Project
Residence for Mr. JAYKUMAR

Drawing Title
GROUND FLOOR PLAN-R4

Drawing Title
FIRST FLOOR PLAN-R4

Drawing Title
TERRACE FLOOR PLAN-R4

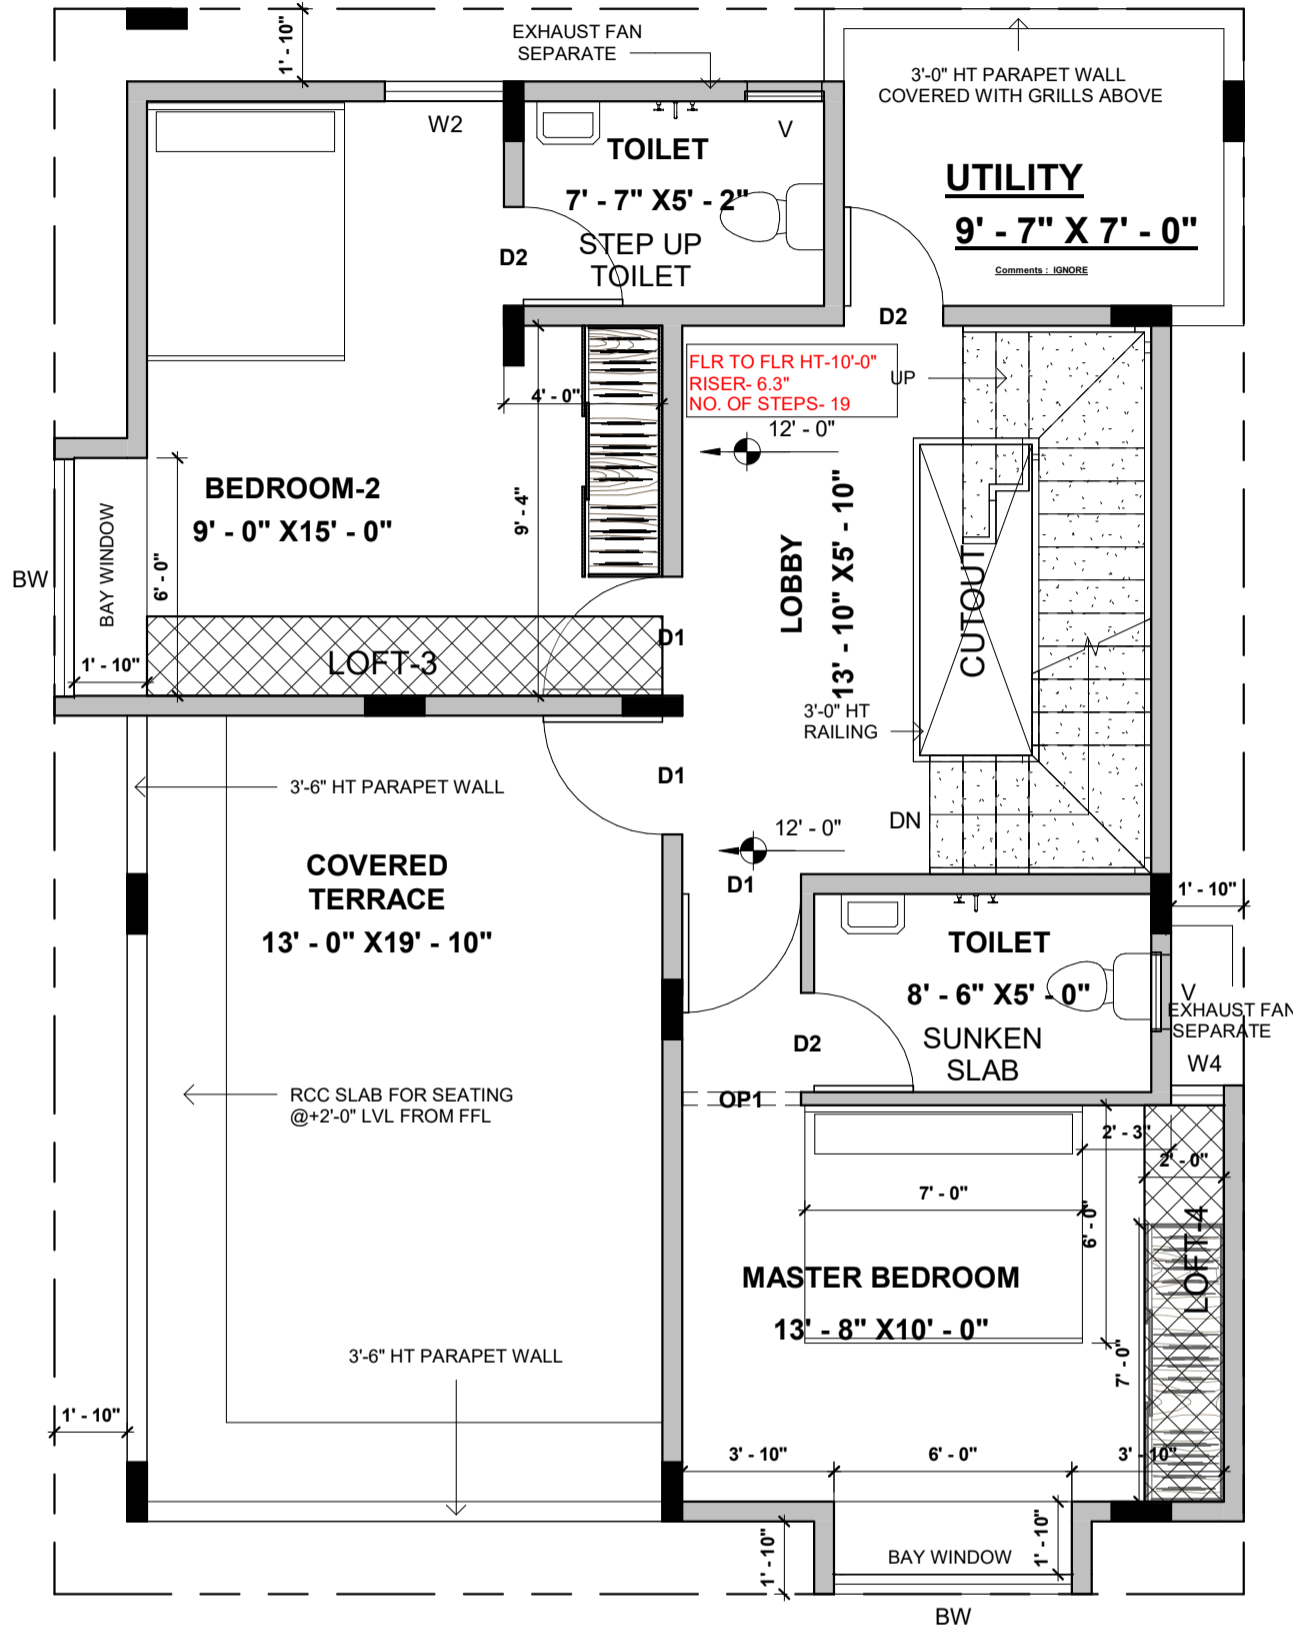
- R1- GROUND FLOOR PLAN**
1. POOJA DIMENSION
 2. WINDOW CHANGES AS PER CLIENT REQUIREMENT
 3. UTILITY INCREASED UPTO COMPOUND WALL IN EAST DIRECTION
 4. LIVING- DOUBLE HEIGHT
- FIRST FLOOR PLAN**
1. EXTENSION REDUCED IN WEST AND NORTH DIRECTION
 2. UTILITY INCREASED AS PER GROUND FLOOR UTILITY. TERRACE FLOOR PLAN
1. SLAB EXTENDED FOR UTILITY BELOW
- R2**
- FIRST FLOOR PLAN**
1. OPEN TERRACE INCLUDED
 2. BAY WINDOW ADDED
- R2-A**
- GF PLAN**
1. UTILITY INCREASED
 2. STORAGE REMOVED
 3. POOJA REMOVED
 4. ARCH INCLUDED
 5. LOFT INCLUDED
- FF PLAN**
1. LOFT INCLUDED
- R3**
- GF:**
1. UTILITY REDUCED
 2. STAIRCASE ALTERED
 3. ENTRANCE STEPS ALTERED
- FF :**
1. UTILITY REDUCED
 2. STAIRCASE ALTERED
 3. SEATING ADDED TO SITOUT
- R4**
- ALL FLOORS SOUTH WALL EXTEND BY 6" SETBACK IN THE SOUTH SIDE - 1'-6" CLEAR**
- ARCHITECT**

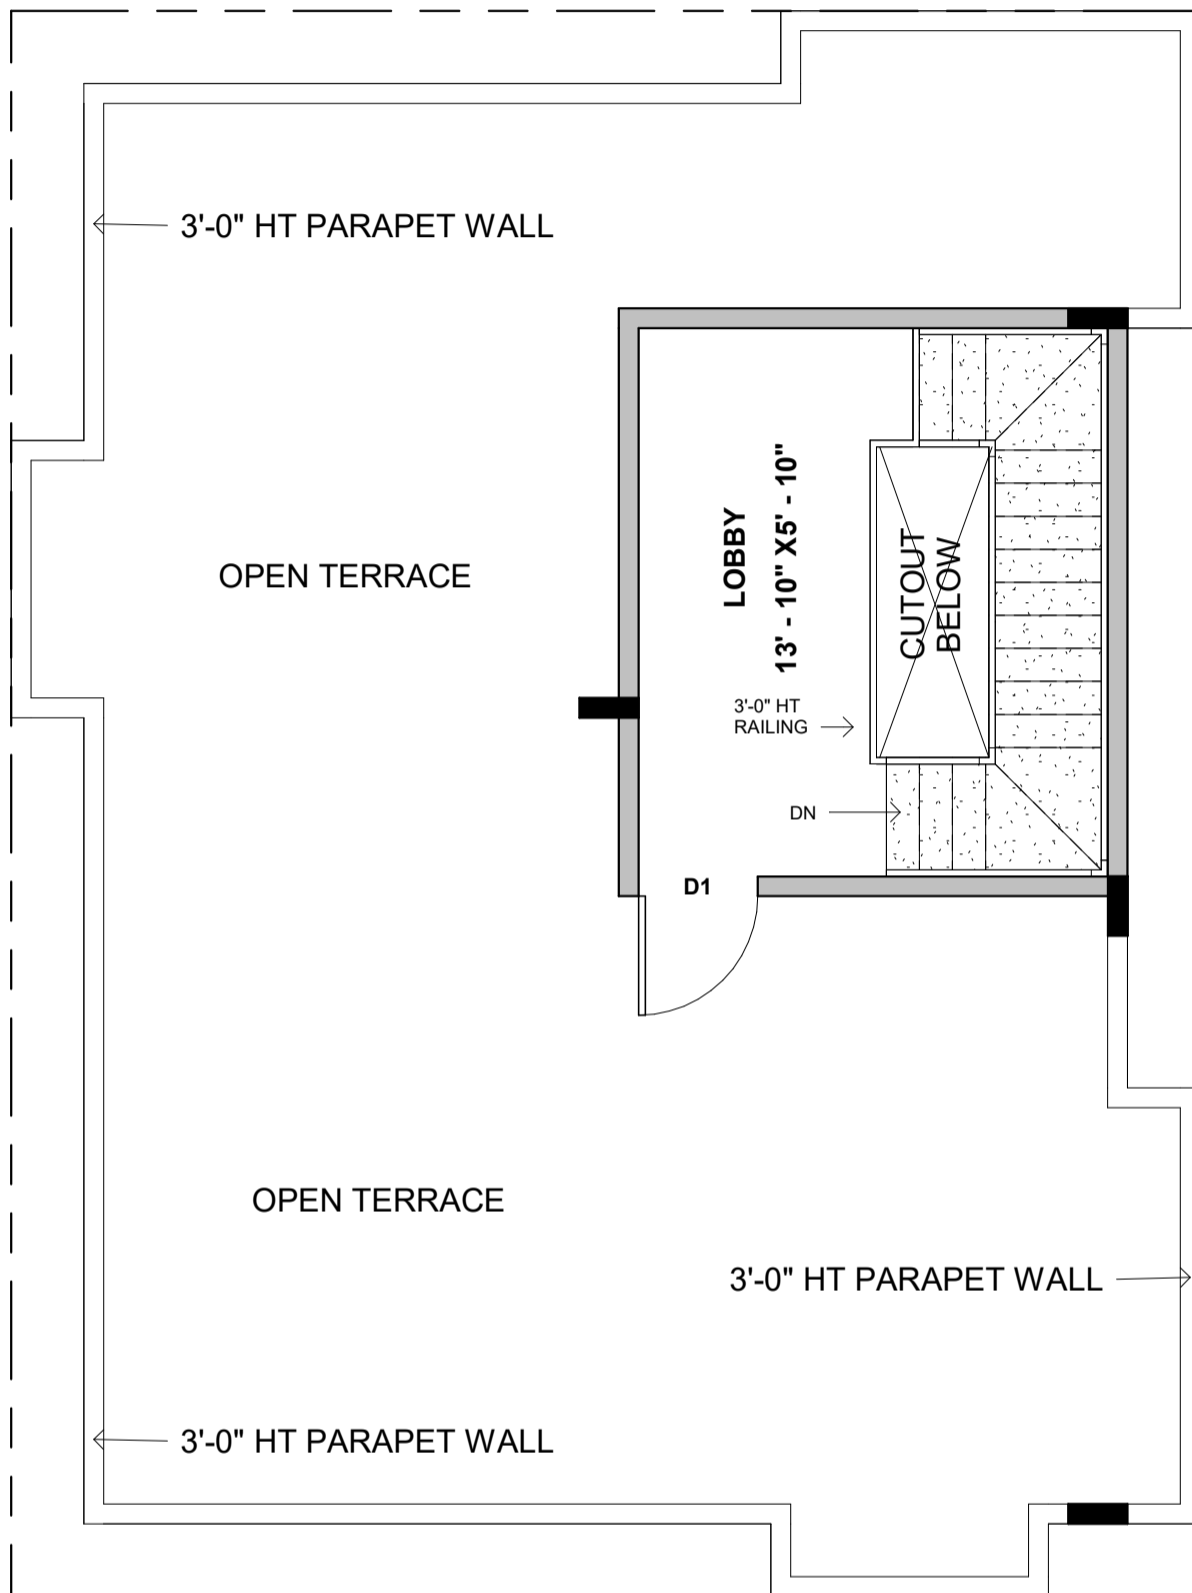
- R1- GROUND FLOOR PLAN**
1. POOJA DIMENSION
 2. WINDOW CHANGES AS PER CLIENT REQUIREMENT
 3. UTILITY INCREASED UPTO COMPOUND WALL IN EAST DIRECTION
 4. LIVING- DOUBLE HEIGHT
- FIRST FLOOR PLAN**
1. EXTENSION REDUCED IN WEST AND NORTH DIRECTION
 2. UTILITY INCREASED AS PER GROUND FLOOR UTILITY. TERRACE FLOOR PLAN
- 1. SLAB EXTENDED FOR UTILITY BELOW**
- R2**
- FIRST FLOOR PLAN**
1. OPEN TERRACE INCLUDED
 2. BAY WINDOW ADDED
- R2-A**
- GF PLAN**
1. UTILITY INCREASED
 2. STORAGE REMOVED
 3. POOJA REMOVED
 4. ARCH INCLUDED
 5. LOFT INCLUDED
- FF PLAN**
1. LOFT INCLUDED
- R3**
- GF:**
1. UTILITY REDUCED
 2. STAIRCASE ALTERED
 3. ENTRANCE STEPS ALTERED
- FF :**
1. UTILITY REDUCED
 2. STAIRCASE ALTERED
 3. SEATING ADDED TO SITOUT
- R4**
- ALL FLOORS SOUTH WALL EXTEND BY 6" SETBACK IN THE SOUTH SIDE - 1'-6" CLEAR
- ARCHITECT**
AISHWARYA RAM
